NAUTICAL CARTOGRAPHY WORKING GROUP (NCWG)

NCWG Letter: 05/2016

Subject: NCWG2 Actions 10, 15, 23, 25, 26, 43

NCWG2 Actions 10, 15, 23, 25, 26, 43

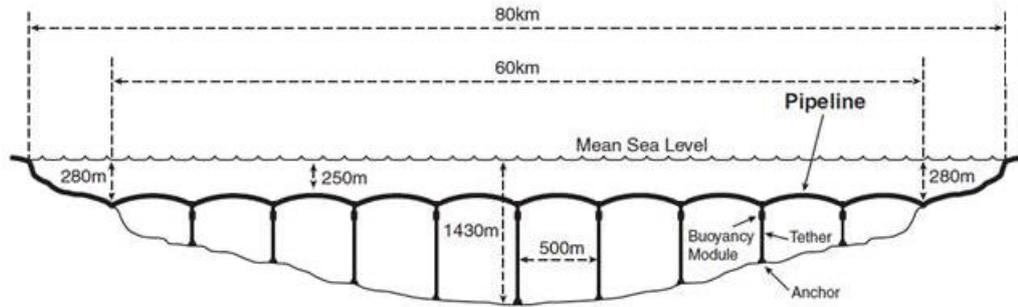
Bülent Gürses (TR) showed some pictures of the construction phase of the sub-surface floating pipeline, which helped the meeting understand the details of this feature. The recommended addition to S-4 in the paper was generally accepted with the following amendments:

The example diagram should be adjusted to remove the appearance of buoys above the pipeline and to show the depth marker above the highest part of the arc.

Taken from EN NCWG2-08.04A, with changes following NCWG2 discussions in red. I have changed ‘anchored’ to ‘tethered’ and ‘pontoon’ to ‘buoyancy modules’ to match the diagram, but retained ‘anchored’ in the chart note, as it is probably a more familiar terms for mariners.

B-444.9 **‘Sub-surface pipelines’** describes pipelines that are floating in the water column. They are ~~anchored~~ **tethered** to the sea floor at regular intervals with large ~~buoyant ‘pontoon’~~ **‘buoyancy modules’** on the anchor hawsers, a little below the actual pipeline, so that it is submerged to a designed minimum depth. These pipelines do not generally constitute a danger to surface vessels, but are potentially a danger to submarines, and submarines and deep trawlers could ~~be a danger to damage~~ the pipeline. A ~~sample~~ **sample** schematic diagram of a ~~typical suspended submarine submerged~~ **sub-surface** pipeline is:

A pictorial representation of the **sub-surface** pipeline, for example as shown above, may be included in addition to, or in lieu of, the note, in magenta, see B-390.1. If the diagram is included in lieu of the note, the legend along the pipeline symbol should read similar to *Water (submerged 250m – see Diagram)*.
